Office Action Summary

10/710,761

DETAILED ACTION

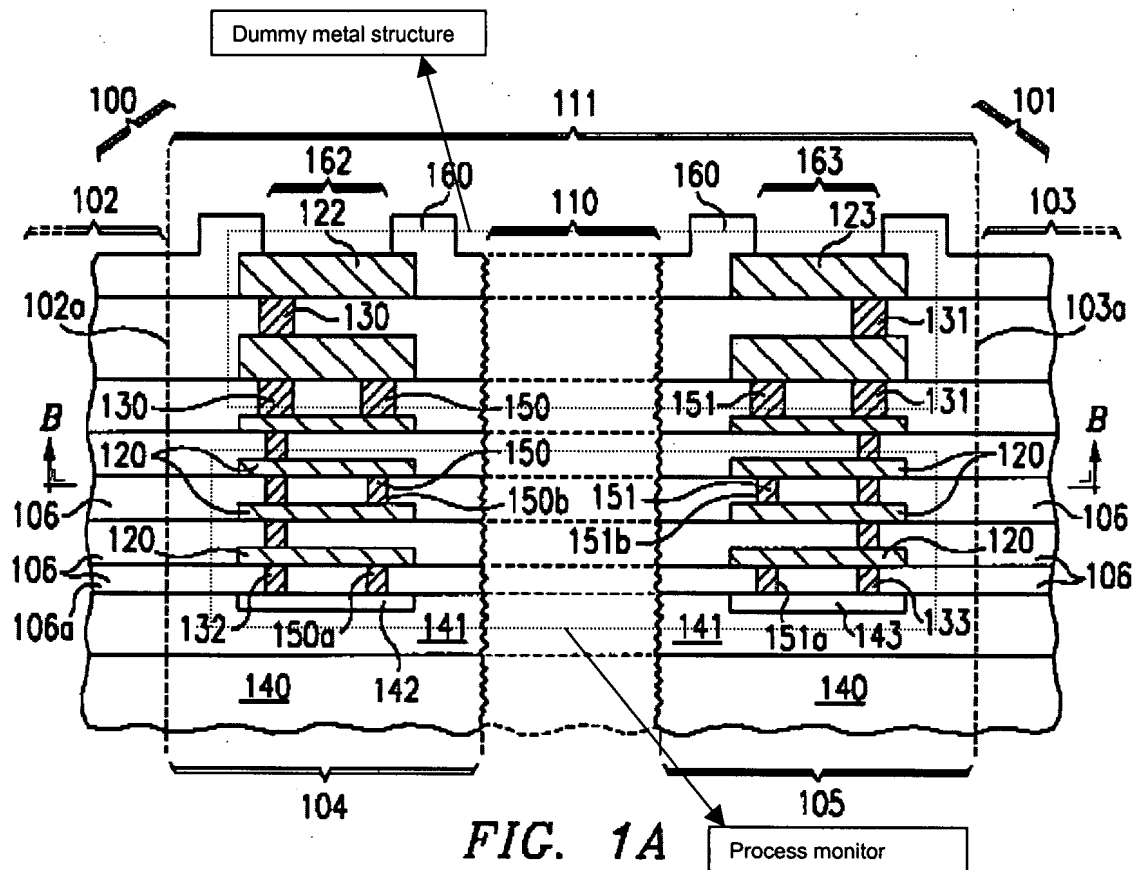
With respect to claim 1, West discloses in figure 1A, a scribe line structure, comprising:

a substrate 140;

a plurality of dielectric layers 106 formed on the surface of the substrate 140 comprising a sacrificial structure which functions as the claimed process monitor pattern set in a scribe line region 111.

West further teaches a dummy metal structure (see figure 1A below) formed on the surface of the substrate 140 connecting with the process monitor pattern and exposed in the scribe line region.

With respect to claim 3, West discloses the scribe line structure of claim 1 wherein the dummy metal structure (see fig. 1A above) comprises a plurality of dummy vias 130.

With respect to claim 4, West discloses the scribe line structure of claim 1 wherein the dummy metal structure comprises a plurality of metal layers 122 (see fig. 1A above).

With respect to claim 7, West discloses the scribe line structure of claim 1 wherein the surface of the substrate further comprises a protective layer 160 covering two sides of the surface of dielectric within the scribe line region (see figure 1A).

West further teaches a heat irradiative structure (dummy metal structure – see fig. 1A above) formed in the plurality of dielectric layers 106 connecting the plurality of dielectric layers with the surface of the substrate and exposed in the scribe line region 111 (metal layers 122-123 exposed in scribe line region 111).

With respect to claim 13, West discloses the scribe line structure of claim 8 wherein the heat irradiative structure (dummy metal region) connects with the process monitor pattern (see figure 1A above).

Given the broad scope of applicant's claims 1 and 8 in particular, the prior art, West et al ('975), meets the limitations of the claims as discussed above. West's scribe line region 111 includes the regions 104, 110 and 105. Please note that the lower part of the structure (boundary shown in square dotted line in figure 1A above) that is the

process monitor pattern, and the upper part of the structure (boundary shown in dotted lines in figure 1A) that is the dummy metal structure are placed within the scribe line region 111, and as such meet the limitations presented in independent claims 1 and 8. Moreover, in light of the language presented in the claims, West's semiconductor structure has the process monitor pattern and the dummy structure (see figure 1A) that makes it capable of performing as alignment marks.
